2015 Michigan Residential Code Errors and Conflicts

The following are errors and conflicts that have been identified at this point. The Bureau of Construction Codes has reviewed these issues. The Director of Department of Licensing and Regulatory Affairs has delegated the authority to make, and has approved, the following interpretations which are advisory.

FIGURE R507.2.1(2)
PLACEMENT OF LAG SCREWS AND BOLTS IN BAND JOISTS

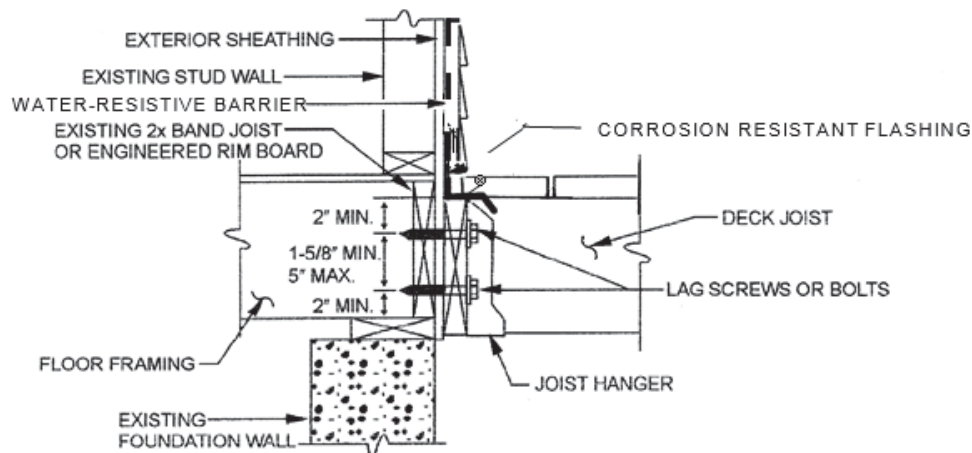
Figure R507.2.1(2) was obviously corrupted during the publication of the rules and was not noticed until it was published by the International Code Council. The figure that must be used by all enforcing agencies is now provided.
